Letter Amendment to Administrative Decision NSA-12-05-L1

PROJECT: To construct a redundant transformer sequence (transformer, breaker, voltage regulator, regulator bypass structure, and underground conduits) within the fenced area at the existing Underwood Substation, and to install an oil and water separator vault and grass lined swale outside of the fenced area.

Project: Underwood Substation Upgrade
Subject: Underwood Substation Land Use Permit Update_Rev 2
Date: March 6, 2015
To: Brent Bischoff, Melanie Sharp
From: Josh Doering, P.E.

Civil

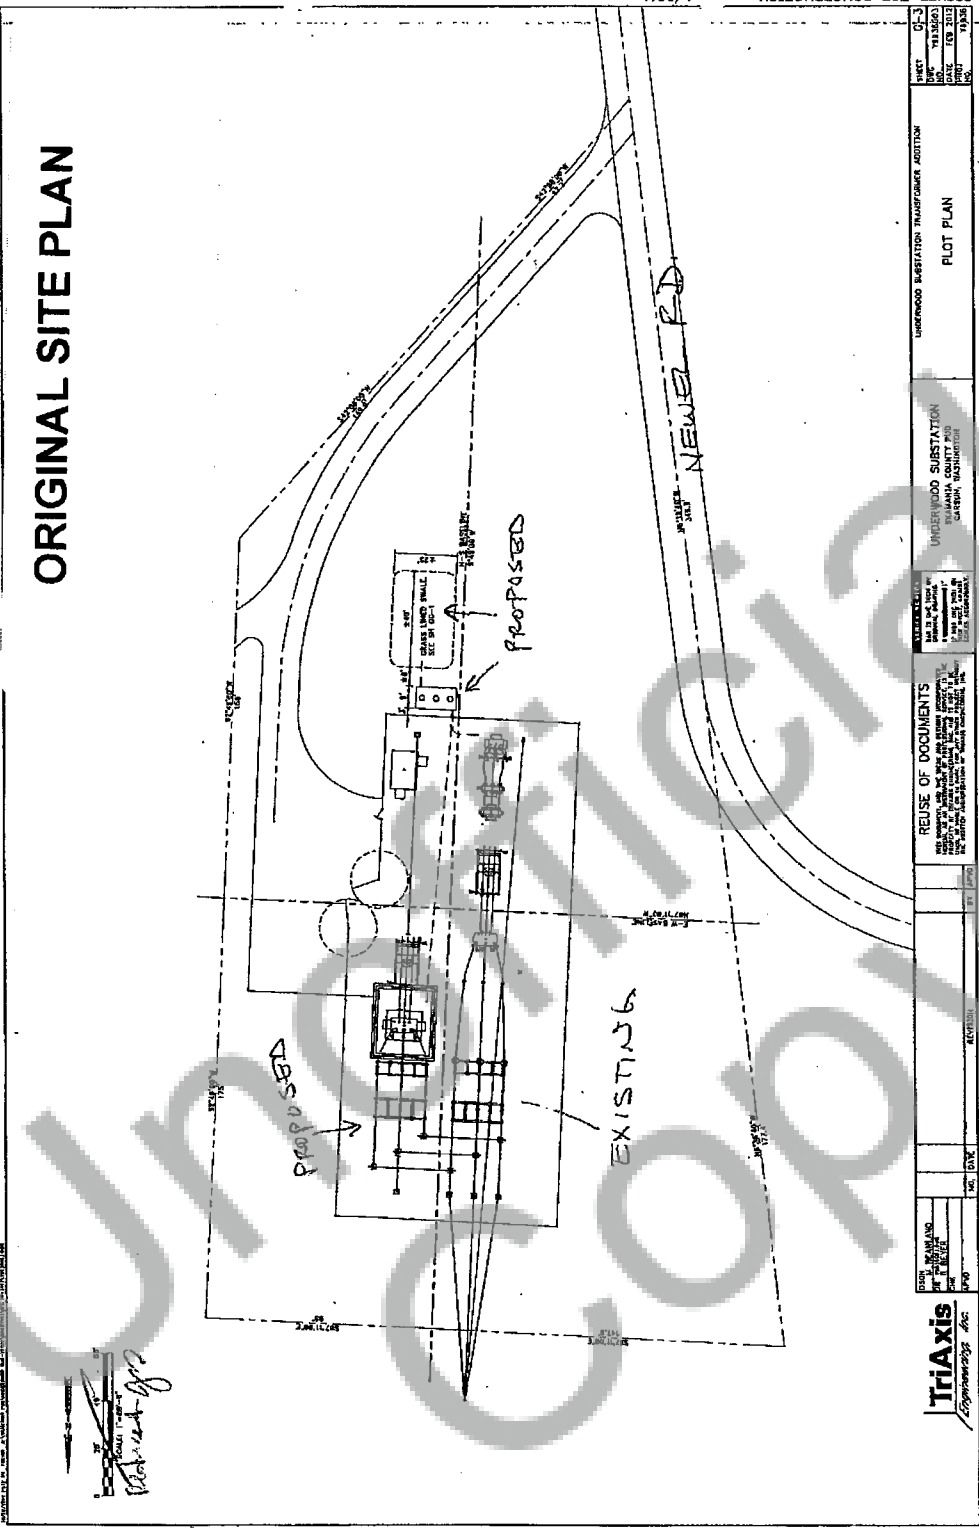
Also, due to space constraints in the new transformer bank, a short temporary construction ramp will be added to the south of the substation to connect the existing driveway to the south substation fence. A twenty-foot double-swing gate will be added at this access point to allow crane and equipment delivery access to the substation for the construction process. This temporary ramp will be removed after construction and the area re-seeded with a native mix. See drawing C1 for temporary construction ramp routing.

The disturbed earth required for equipment foundations of the current design will remain approximately the same as the original design. However, with the addition of the temporary construction ramp to the Substation from the south, there will be limited additional disturbed area. The temporary construction ramp is designed to allow the transformer, and the crane required for its installation, straight access to the foundation pad with minimal slope changes (lowboy trailers). The modification will not encroach within 50 feet of Newell Road, or within 20 feet of the front property line. This temporary modification will affect an area up to 32 feet wide and 180 feet long (4,680 sq. ft.). Some of this disturbed area will coincide with the existing driveway location, as the construction ramp intersects with the existing driveway. As the temporary construction ramp will need to be 2-3 feet above the existing ground level for crane and equipment delivery access reasons, it will require the addition of approximately 245 cubic yards of engineered fill. After the project is complete, the temporary construction ramp will be removed and the disturbed area re-seeded with a native seed mix. Also, as the total disturbed area of the Substation project is only 0.15 acres, a construction stormwater permit is not required. Necessary BMP's will be implemented to counteract any construction stormwater runoff.
